We Can Do Better

PHASE1ESA.CA
DUE DILIGENCE DONE RIGHT

CASE No. 1

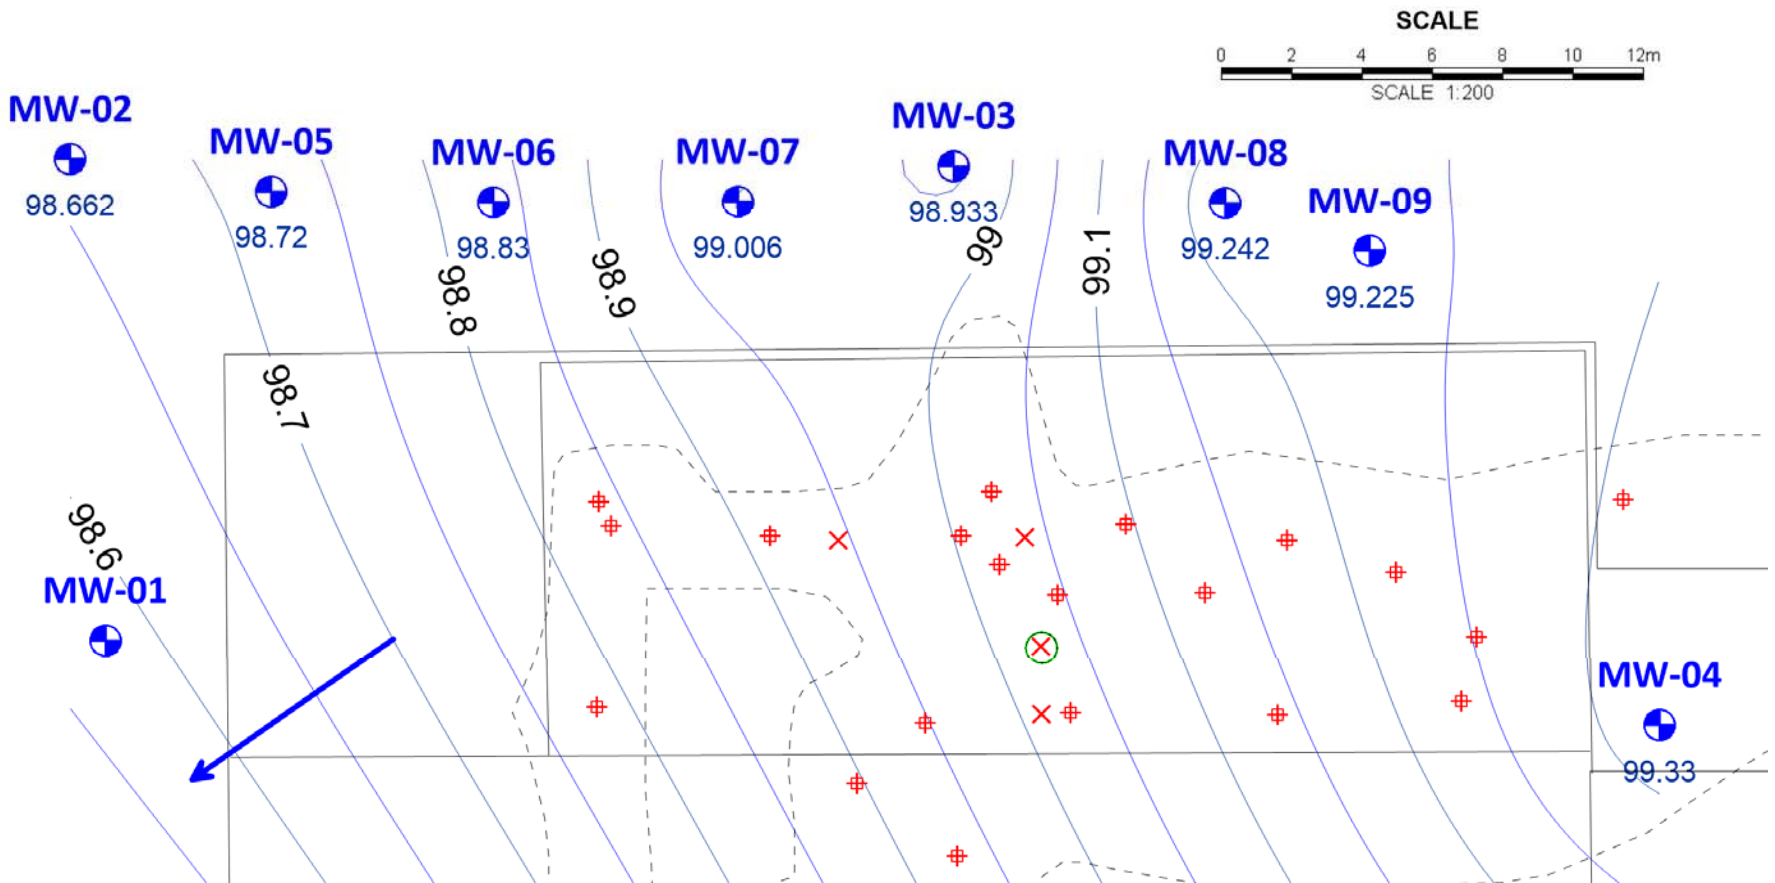
- 1. Not Northerly towards the Big River.**
- 2. Not East-Northeast towards the  Creek Ravine.**
- 3. Not North-Northeast either!**

I recommended doing a groundwater elevation survey to FINALLY determine the direction of shallow groundwater flow. Here's what we found:
